Topic	PF Response
WSCC First round of questions (Additional comments received from WSCC in Red, PF responses in Blue)	
1. Design speed – This is still quoted as 30mph. However, no reference to the WSCC Speed Limit Policy is provided. As such, the applicants should set-out whether-or-not the new A29 road accords with that Policy.	The Design of the A29 is seeking to align with WSCC Speed Limit Policy, however it should be noted there are some outside influences which has impacted and shaped the design process. Further to various meetings with WSCC on the road design in 2019 and 2020 and prior to the submission of the Planning Application there was an agreement between WSCC highways team, WSCC A29 delivery team and The Southern Consortium that the A29 would be subject to a 30mph design speed. Reference to these discussions are highlighted in our Design Statement. In line with WSCC Speed limit policy the main elements are, the road will need to demonstrate that any design speed chosen is self-enforcing and this will

Table 5-2: Cycle lane and track widths

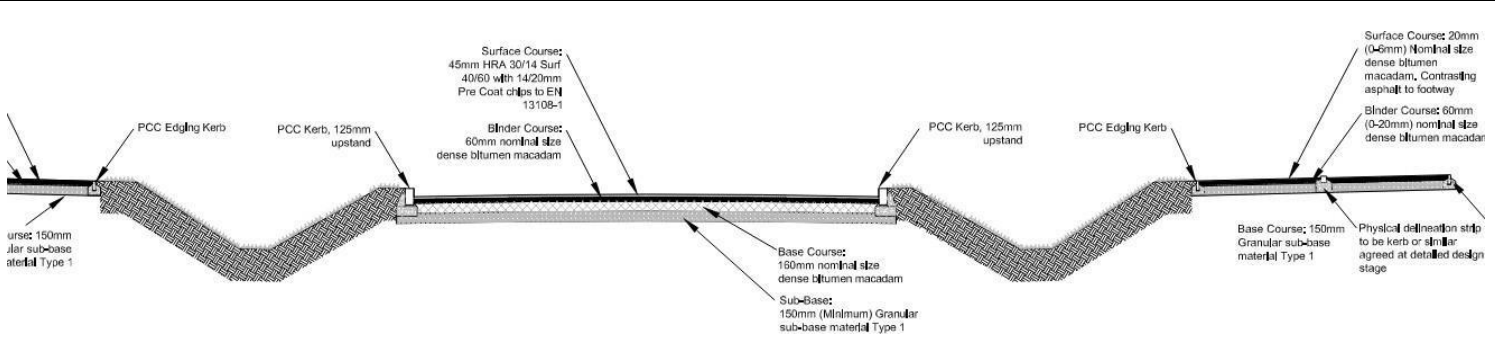
Cycle track width to be widened to provide for two-way flows on both sides of the new road

We anticipate less than 200 cycles per hour.

Figure 3.53 Visibility measured at entry to pedestrian crossing at next exit

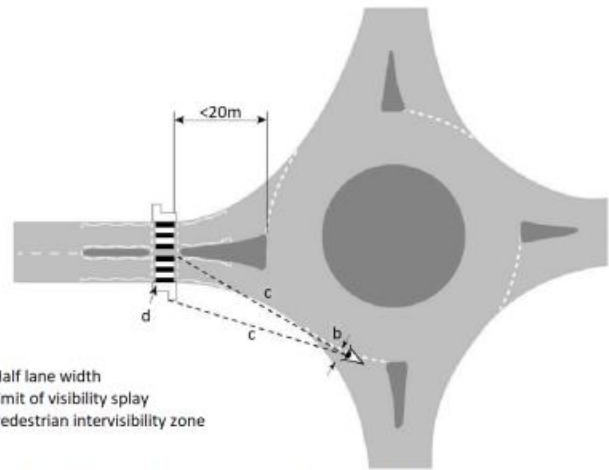
Plan A13394-PF-ZZ-SK-DR-CD-00101 P08 (A29 Link Road – General Arrangement - Sheet 2 of 10) – Controlled crossing needs to be moved to 20m away from the RBT stop lines. Currently it is shown 4-5m closer. Give way marking for cyclists may also need to be reviewed at detailed design stage to check they are correct.

*A13394-PF-ZZ-SK-DR-CD-00101 is in line with CD116 3.53.1 which requires the crossing to be <20m or not sited between 20 metres and 60 metres of the give way line. Please see extract below (red circle signifies 20m zone) Clarification required
PF comment: See below extract from CD116 figure 3.53 showing spacing that is required is less than 20m:*

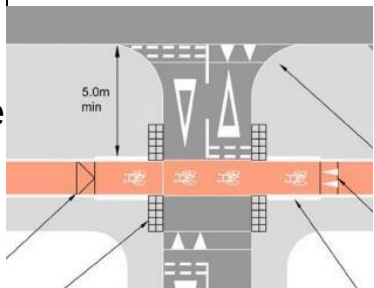
Uncontrolled crossing including dropped kerbs needed for southern arm island – need to cater for desire-line for peds and cyclists here too. And, additional margin between edge of road and cycle path where it goes over railway bridge required (see comments at foot of this response).

As indicated previously we consider these roads Secondary roads and have provided details on Shared provisions being provided. Also note East/West Link and Barnham Station Link are in the outline application only WSCC will propose conditions be attached to any planning consent recommending a segregated route (or routes) alongside the E-W Link, Bus Link and the link between Church Lane and St. Phillip Howard School.

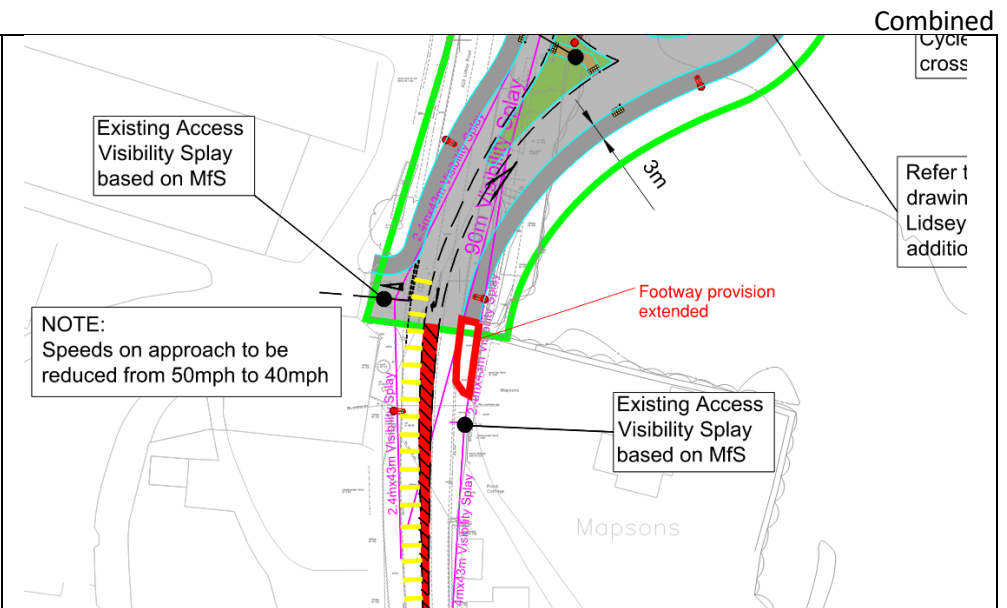
Visibility splays affected by the proposals are indicated on drawing A13394-SK035 TRO Layout. Please provide plan showing existing splays and proposed splays with an explanation about any differences so WSCC can then consider.

PF comment: PF to provide additional plan showing existing visibilities. PF to provide a Departures from Standard if existing visibilities are being affected by our works and do not meet DMRB requirements.
